3	Tender Section- C Sub Section-2 Annexure- S-2/C-1/4	GELO as per Section -2 Chapter-1 Annex- S-2/C-1/4	Revised GELO is attached with this corrigendum and to be referred for tendering purpose.

TECHNICAL CORRIGENDUM POINT (TENDER NO.: RPRC182491)

Piperack Section over flyover

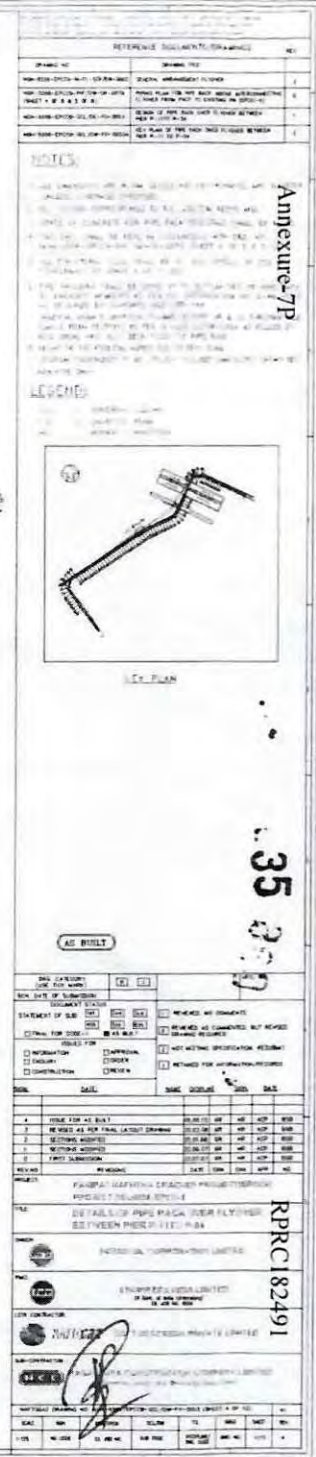
Existing pipes are not occupying entire width of the piperack Hence load from new pipes will be checked w. r. t. considered load on piperack.

Max. UDL due to New pipeline (due to 14" pipe line) = $2 \text{ kN} / (0.275 + 0.175 + 0.05) = 4.0 \text{ kN/m}$

Which is less than minimum UDL considered for design (= 6.75 kN/m)

Also column section provided is UC 254 x 254 x 73

Area of cross section = 9310 mm^2

Effective length of column = $1.2 \times 4 = 4.8 \text{ m}$

Slenderness ratio = $4800 / 64.8 = 74$

Permissible compressive stress = 125 N/mm^2 for buckling class d.

Hence load carrying capacity of column = $125 \times 9310 / 1000 = 1163.75 \text{ kN}$

Additional load due to new pipelines = $2 + 1.3 = 3.3 \text{ kN} \ll$ Permissible capacity (=1164 kN)

Wind Load-

Referring to document No. 6556-EPCC9-IN-FL-STR-DC, clause 10.1.7 for transverse wind loading calculated depending on the width of the Pipe Rack as,

"To calculate wind load in transverse direction of piperack, a projected height of $1.25\text{m}/1.5\text{m}/2.0\text{m}$ shall be considered on all tiers irrespective of height between two tiers of rack widths of $4\text{m}/6\text{m}/8\text{m}$ and 10m respectively. For piperacks of widths greater than 10m , the above projected height shall be taken as $0.8[\text{diameter of largest pipe including insulation (m)}] + \tan 10^\circ[\text{width of rack (m)}]$. However, this shall not exceed the height between consecutive tiers."

This proves that wind loading on future pipes is already considered for the design of Piperack.

Hence no need to check wind load condition for the additional piping.
